**Draft consolidated amendments to Regulation No 79 discussed during
the eighty-fourth session of GRRF**

Regulation No. 79,

Fig. 1

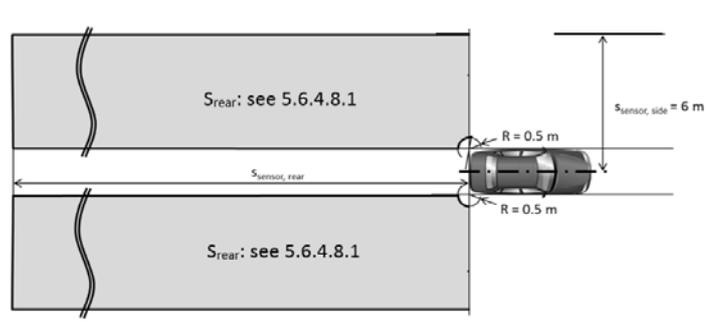
5.6.4.8.2. The vehicle system detection area on ground level shall be at minimum as shown in the figure below.
